PLANNING TECHNICAL REVIEW COMMITTEE –AGENDA

1. 10:30 AM – 11:15 AM: Site Review for First Street at Garrison, LLC, Assessor's Map 6, Lots 3-1 & 9, zoned CBD - General, located at First Street. (Proposal is to re-use the existing building and construct one new building, the first building with 24 two bedroom units and 8 one bedroom units also containing 1,520 sq. ft. of commercial space and 17 covered parking spaces with the second building containing 1 two bedroom units and 5 one bedroom units also with 2,412 sq. ft. of commercial space and a total of 55 proposed parking spaces on site. A CUP and LLA application will also appear before the Planning Board). (P18-25)

TECHNICAL REVIEW COMMITTEE MINUTES - P18-37

- o Change name of project **Changed to "Rivers Mark", all sheets**

SHEET 6

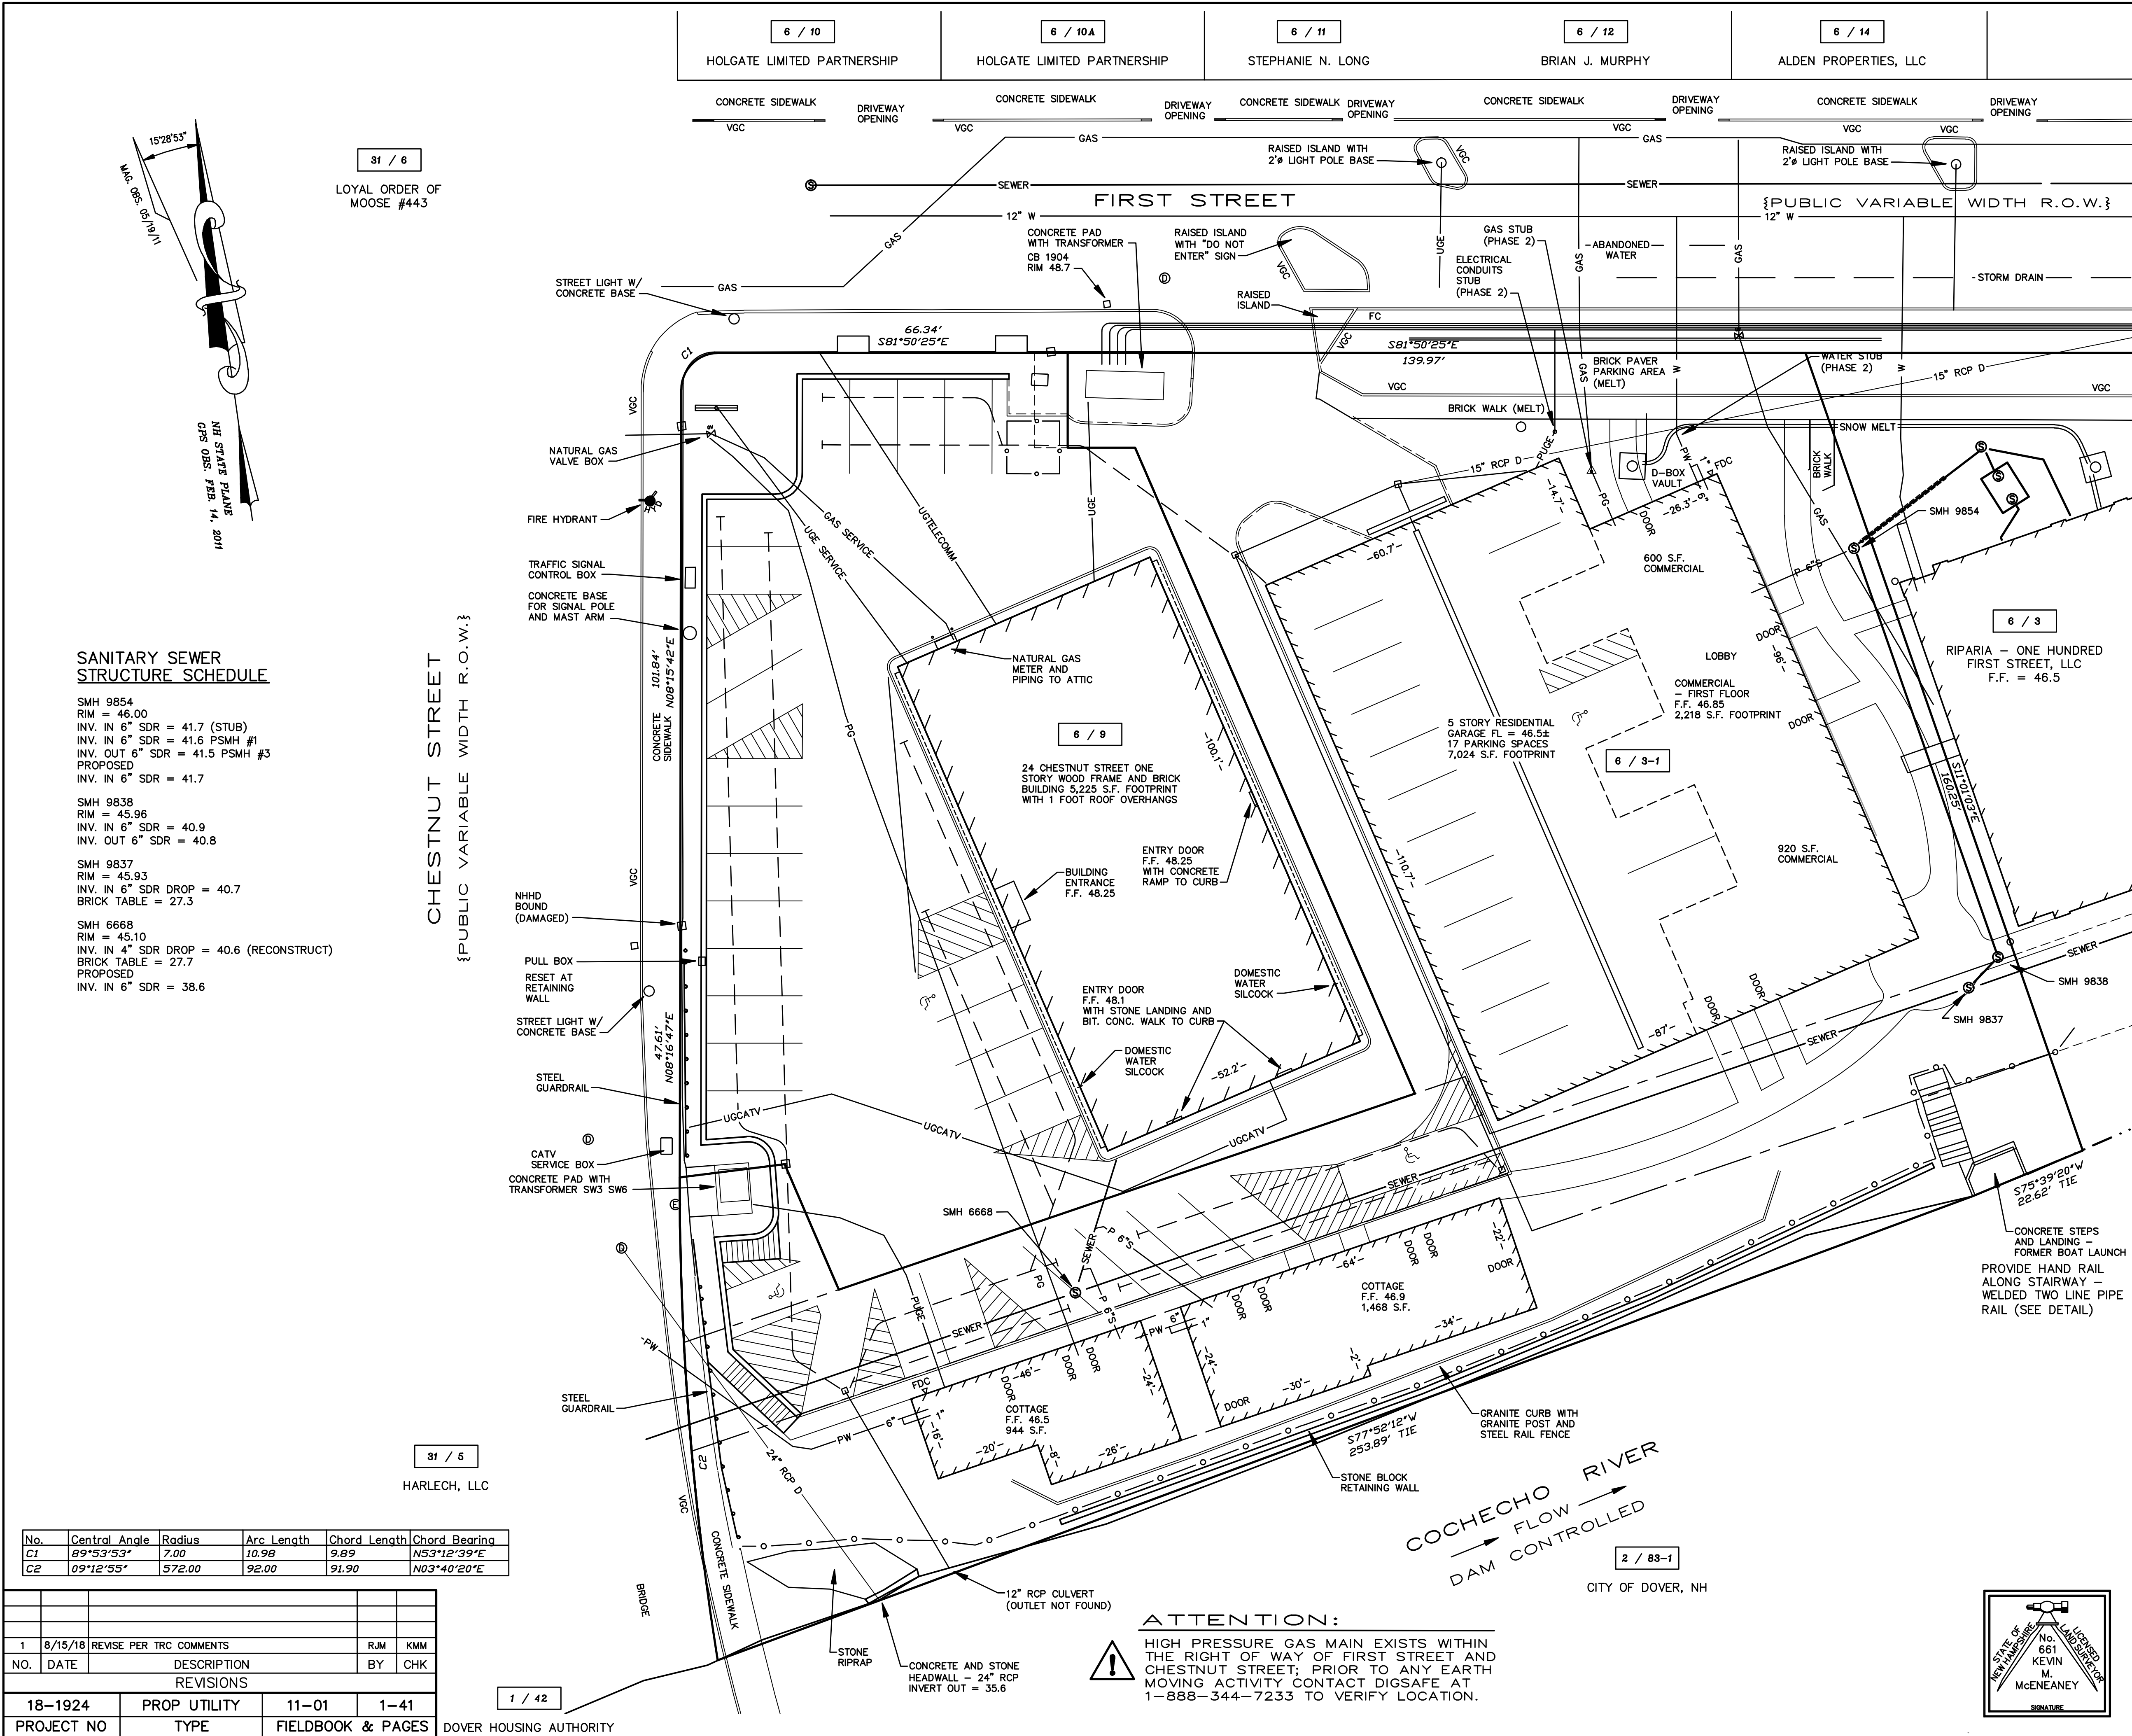
- o Sheet 6:
 - ☐ Clarify domestic water and sprinkler supplies to the proposed structures. **Done**
 - ☐ Clarify UGE to structures **Done**
 - ☐ Clarify gas to the two cottage buildings along the water **Done**

- Add planning file number 18-25
- Add Rev 1 – 8/15/18 to block
- Add FF Elev 46.5 to Parcel 6/3
- Add note on plan at former boat launch to provide hand rail
- Remove CB symbol at CB 6667
- Revise plan to show additions of utilities with labels onto site plan – UGE, GAS, WATER including split for fire and domestic services
- Revise plan showing elimination of two SMH's at mixed use buildings and providing for Sewer Service Lines to same and service from 24 Chestnut
- Revise Sanitary Sewer Chart to accommodate for elimination of propsed SMH's PSMH1 and PSMH2
- Rename project to "Rivers Mark"
- Revise plan for parking changes
- Add Dumpster
- Add pervious paver callouts
- Add pervious walk
- Add Conc steps and railing
- Add stripe islands
- Add HC Space in Residential building
- Label curb types

TYPICAL BRICK SIDEWALK SECTION

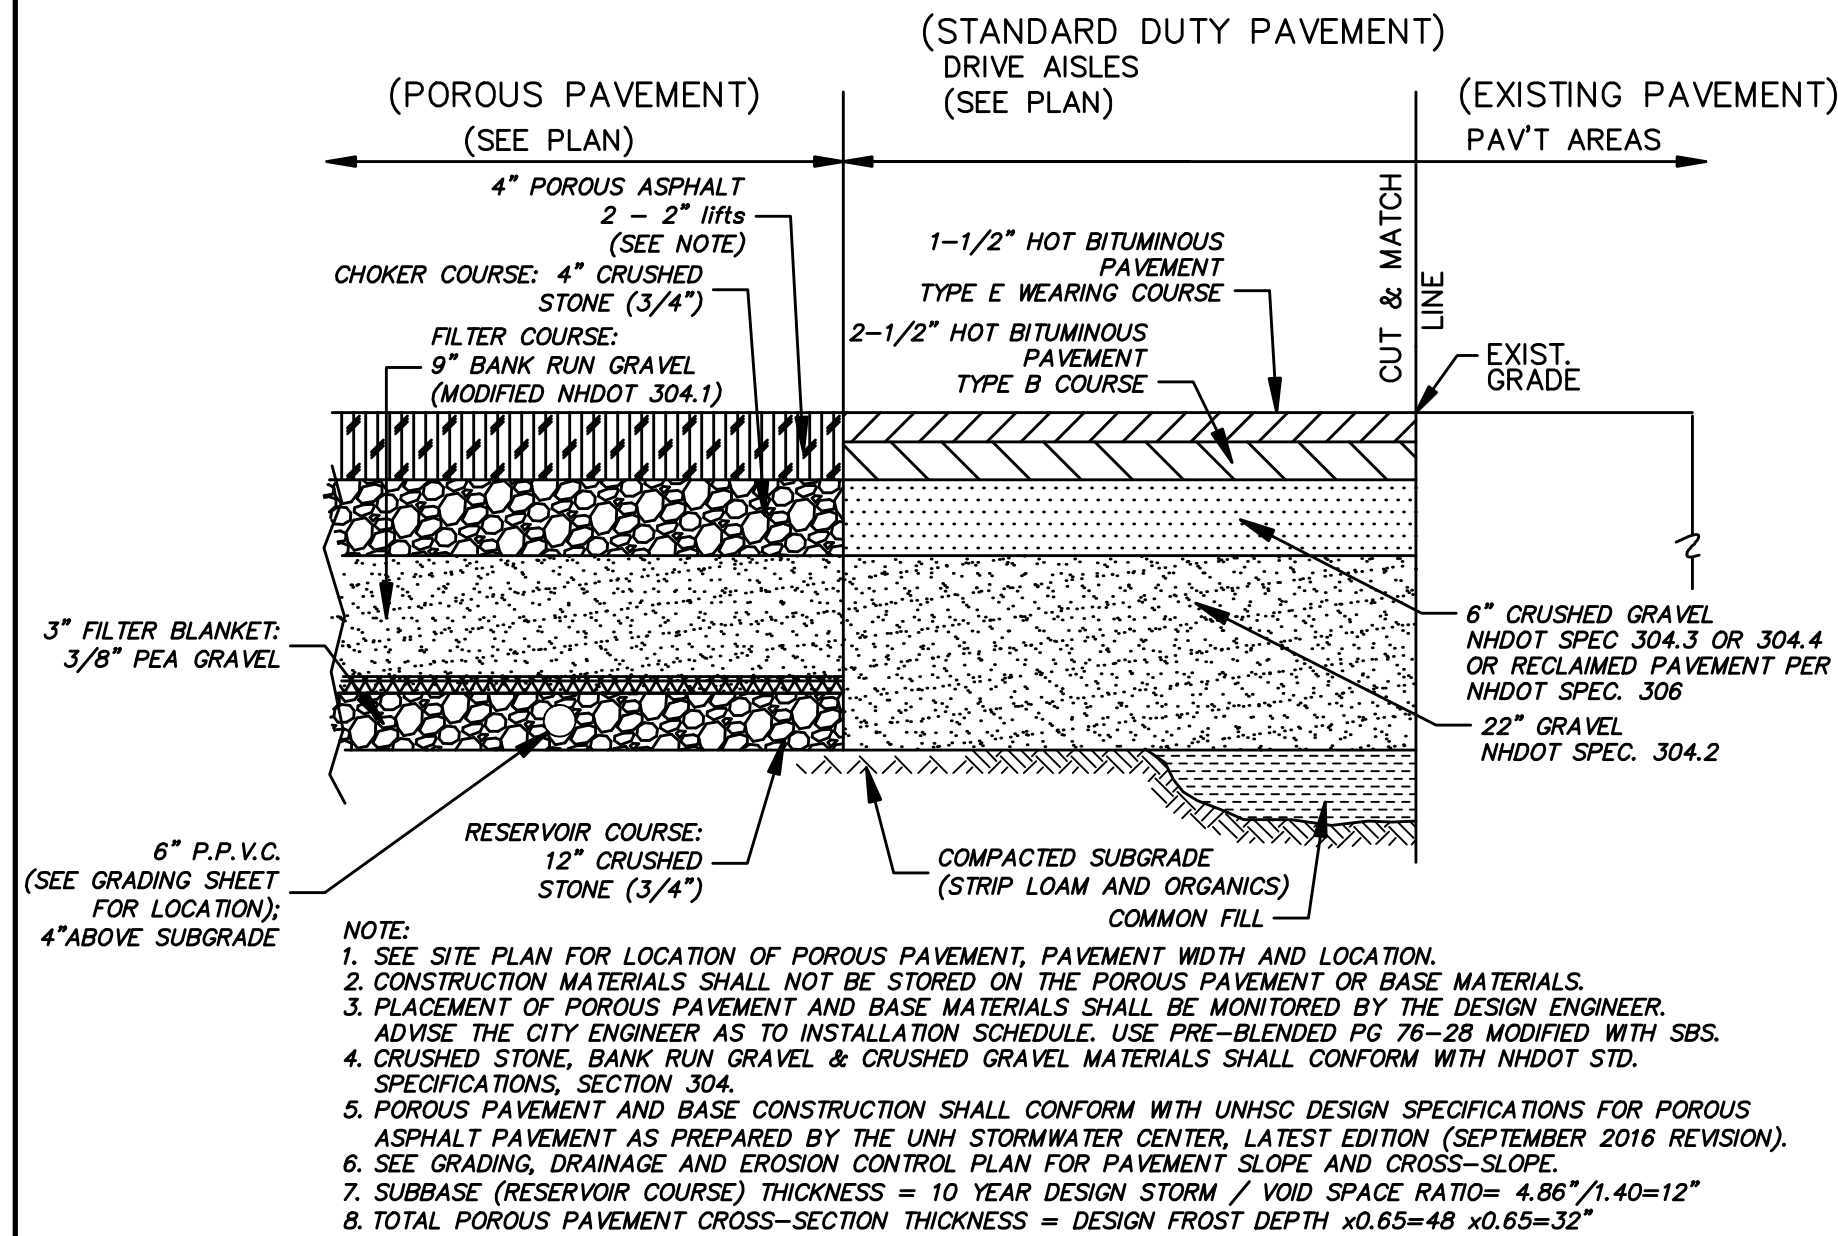
- o Provide masonry wall to screen parking from Chestnut and First Street **Add aluminum fence**
- o Indicate brick sidewalk materials **Detail added to sheet 10**

- Add planning file number 18-25
- Add Rev 1 – 8/15/18 to block
- Add FF Elev 46.5 to Parcel 6/3
- Remove notes
- Add typical brick sidewalk detail
- Add Porous Pavement Detail
- Added Permeable Concrete Paver Detail
- Rename project to “Rivers Mark”
- Add typical retaining wall section
- Add Aberdeen Fence detail

SHEET 14

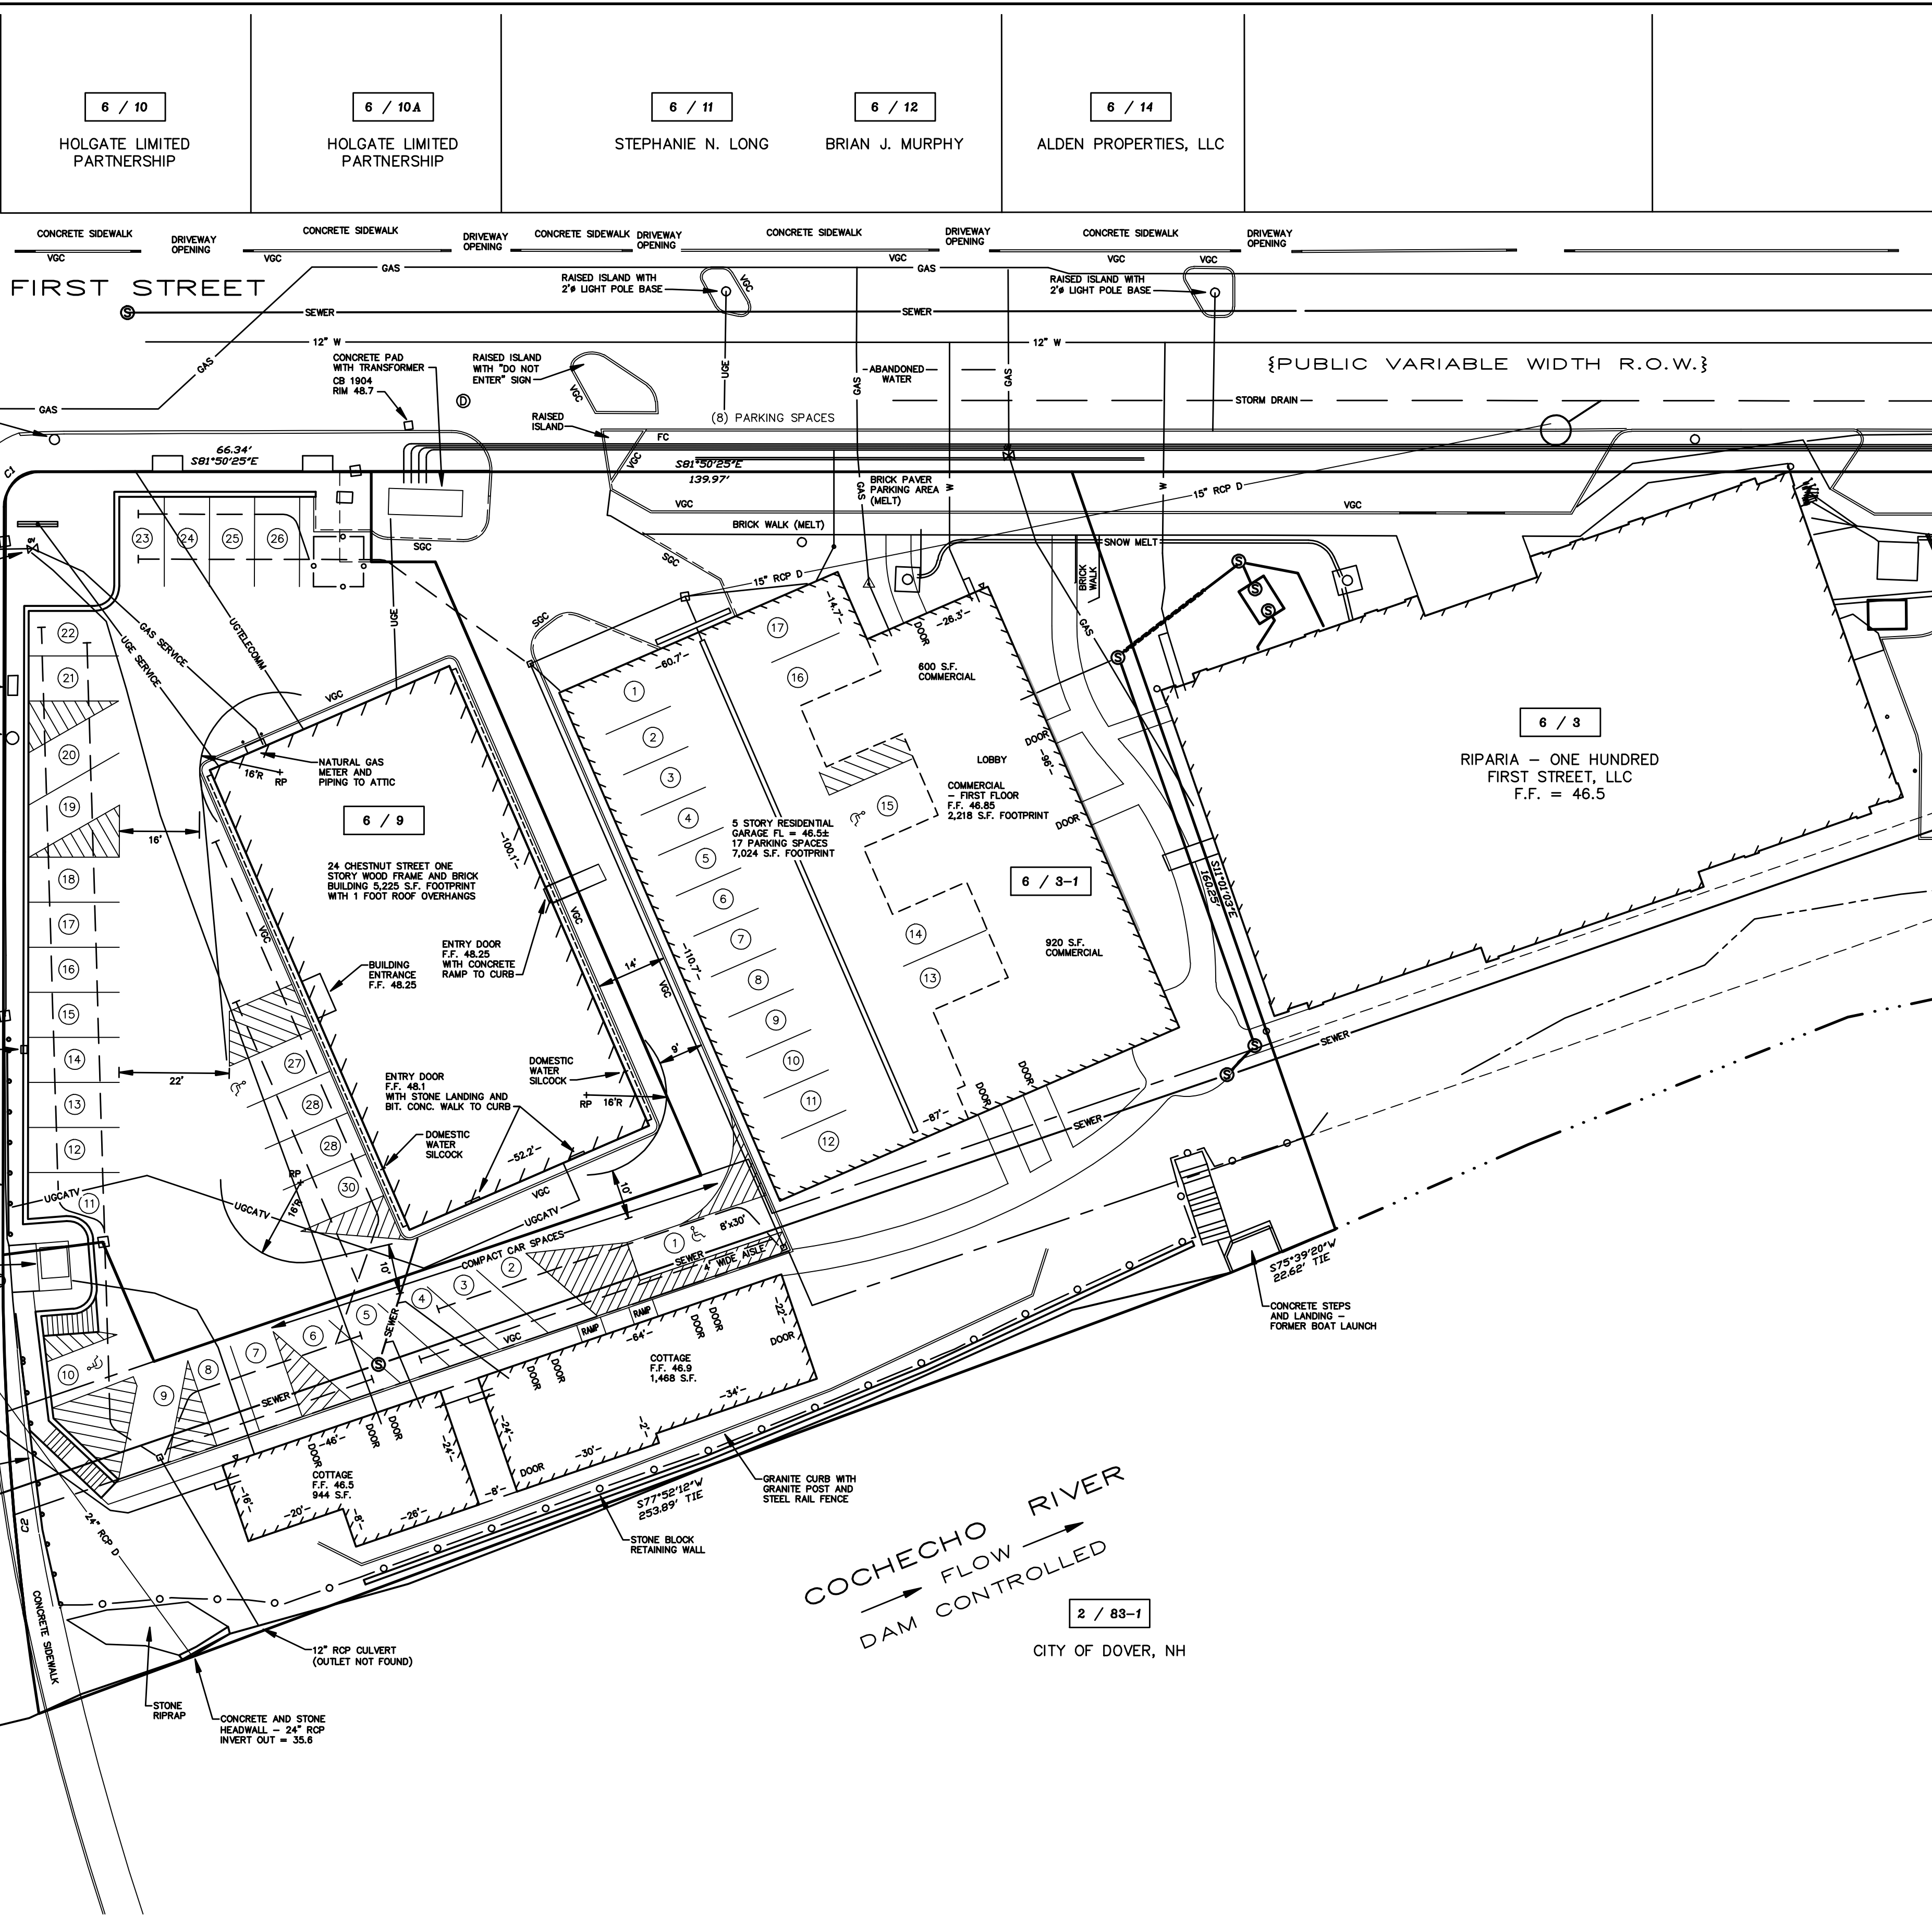
- o Label all street lights **Existing are shown and labeled on Sheet 2**
- o Use proper scale (1" = 20', 30', 40') **Add Sheet 14**
- o Remove drainage under cottage **Done**

- Added to show site at a proper scale (20 scale)
- Rename project to “Rivers Mark”
